UNITED STATES PATENT AND TRADEMARK OFFICE

APPLICATION NO.	FILING DATE	FIRST NAMED INVENTOR	ATTORNEY DOCKET NO.	CONFIRMATION NO.
10/661,545	09/15/2003	Kenji Samoto	117107	9059
25944 7590 03/21/2008 OLIFF & BERRIDGE, PLC P.O. BOX 320850 ALEXANDRIA, VA 22320-4850				
EXAMINER				
FIDLER, SHELBY LEE				
ART UNIT		PAPER NUMBER		
2861				
MAIL DATE		DELIVERY MODE		
03/21/2008		PAPER

Office Action Summary

DETAILED ACTION

Drawing A: Figure 5 from Lim, edited for clarification of rejection

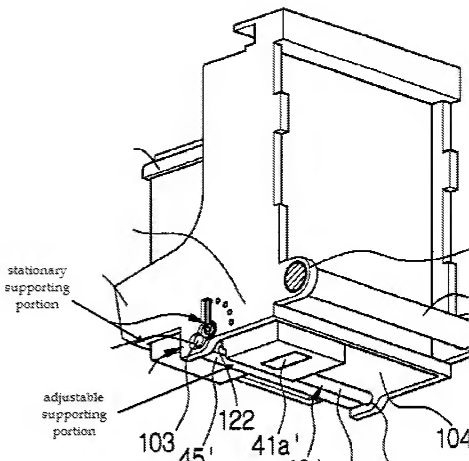
a plurality of supporting portions having respective supporting points where the supporting portions engage and support the recording head (see Drawing A below); and

at least one adjusting device (cam 113 + lever 115) that moves the supporting point of at least one adjustable supporting portion (portion of adjustment shaft 102 supporting lower fixing surface 122) of the supporting portions toward, and away from, the recording medium (col. 5, lines 20-30 & Figs. 2 and 6 show that the head 41' is moved toward and away from the paper P in paper feeder 20), the supporting portions further comprising at least one stationary supporting portion whose supporting point is stationary (Drawing A),

the at least one adjustable supporting portion (102) being provided at a rear position of the carriage so as to define a rear clearance between a rear portion of the recording head and the recording medium (Figs. 2 & 5),

the at least one stationary supporting portion being provided at a front position of the carriage so as to define a front clearance between a front portion of the recording head and the recording medium (Fig. 2 & Drawing A),

Lim as modified by Numata et al. disclose all the limitations of claim 10, and **Lim also discloses** two front stationary supporting portions (each corner between the front and sidewalls comprises a stationary supporting portion - Drawing A) and one rear adjustable supporting portion (Drawing A).

Lim as modified by Numata et al. disclose all the limitations of claim 13, and **Lim also discloses** that the two front stationary supporting portions are provided in a vicinity of the two

side plates, respectively (Drawing A), and the one downstream adjustable supporting portion is provided at a substantially middle position between the two side plates (Fig. 5).
